Joyful View Subdivision Final Drainage Report

December 2023

HR Green Project No: 2202179

PCD File No. SF2231

Project: Joyful View

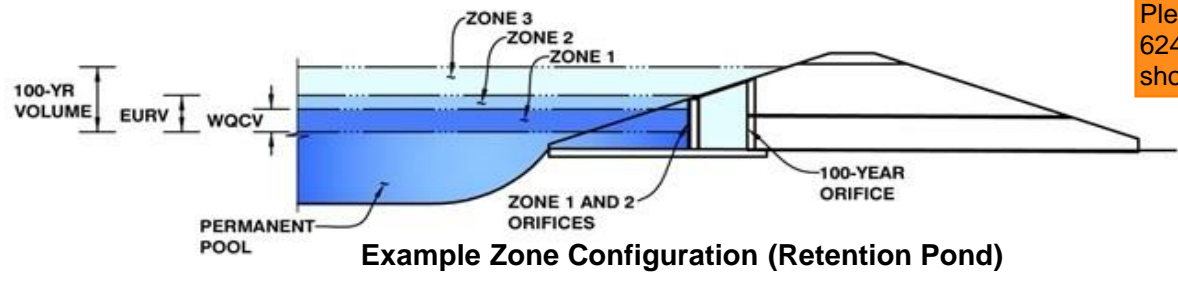
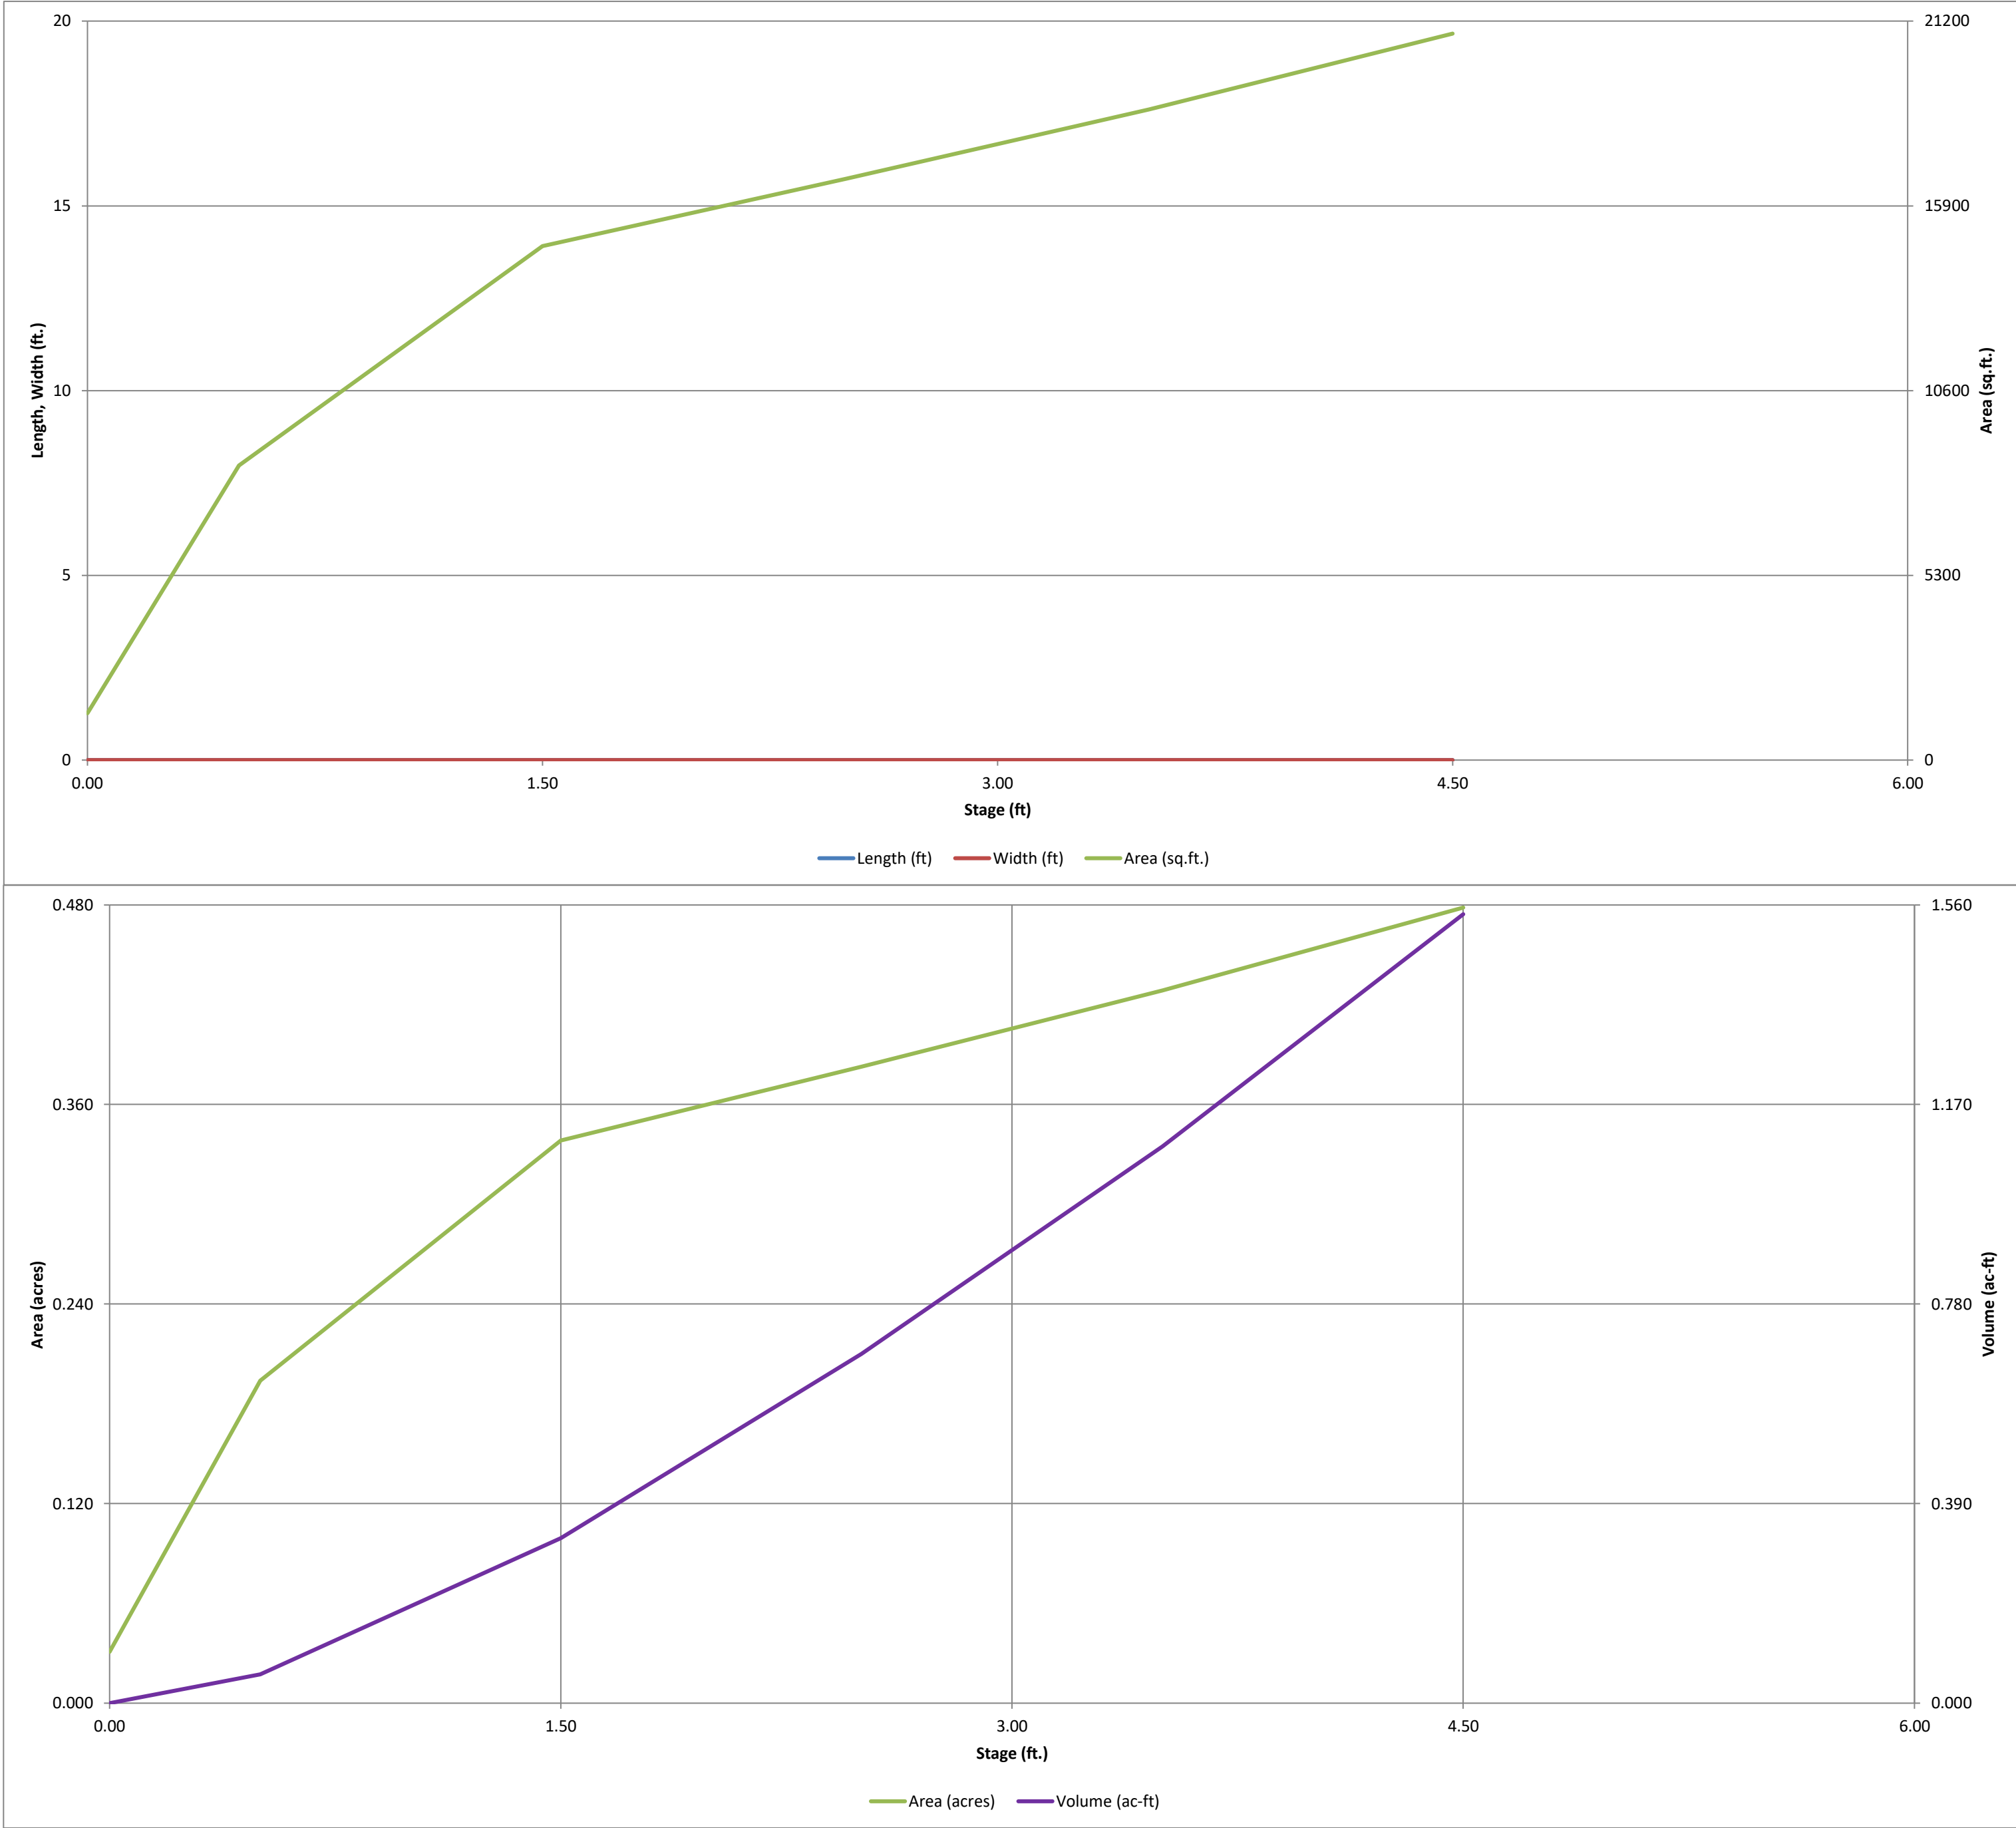
Please revise. Stage=0ft should be at 6249.50, which is the media surface elevation shown on the CDs

Revised.
